Access Compliance Report

Public Rights-of-Way

Intersection ID: 13590	Main Street: CAMDEN_RD	Cross Street: S_TRYON_ST	Location: NE
ADA ID: F0C6A7F699AB	Ramp Type: Perp	Initial Pass/Fail: Fail	Overall Compliance: No
		Severity Score: 12.5

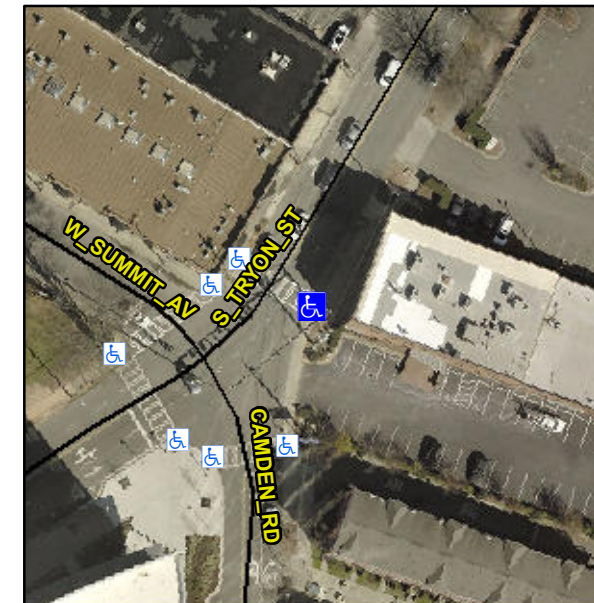
R304.5.3

Compliance	Description	Data	Compliance	Description	Data
N/A	Ramp Length (in)	65.0	Yes	Ramp Slope (%)	5.1
Yes	Ramp Width (in)	48.0	No	Ramp XSlope (%)	5.2
N/A	Flare Type LT	N/A	N/A	Flare Type RT	N/A
N/A	Flare Slope LT (%)	N/A	N/A	Flare Slope RT (%)	N/A
N/A	Flare Traversable LT?	N/A	N/A	Flare Traversable RT?	N/A
N/A	Landing Length (in)	N/A	N/A	DWS Provided?	N/A
N/A	Landing Width (in)	N/A	N/A	DWS Contrast?	N/A
N/A	Landing Slope (%)	N/A	N/A	DWS Length (in)	N/A
N/A	Landing X Slope (%)	N/A	N/A	DWS Full Width?	N/A
N/A	Landing Curb? (Y/N)	N/A	N/A	DWS Offset (in)	N/A
N/A	Shared Landing?	N/A			
N/A	Gutter Ponding?	N/A	N/A	Gutter Slope (%)	N/A
N/A	Gutter Lip Ht (in)	N/A	N/A	Gutter X Slope (%)	N/A
N/A	Painted X Walk1?	Yes	N/A	Painted X Walk2?	N/A
	X Walk 1 Direction	To NW		X Walk 2 Direction	N/A
N/A	X Walk 1 Width (in)	123.0	N/A	X Walk 2 Width (in)	N/A
	X Walk 1 Slope (%)	5.5		X Walk 2 Slope (%)	N/A
	X Walk 1 X Slope (%)	1.6		X Walk 2 X Slope (%)	N/A

Remove & Replace Entire Ramp.
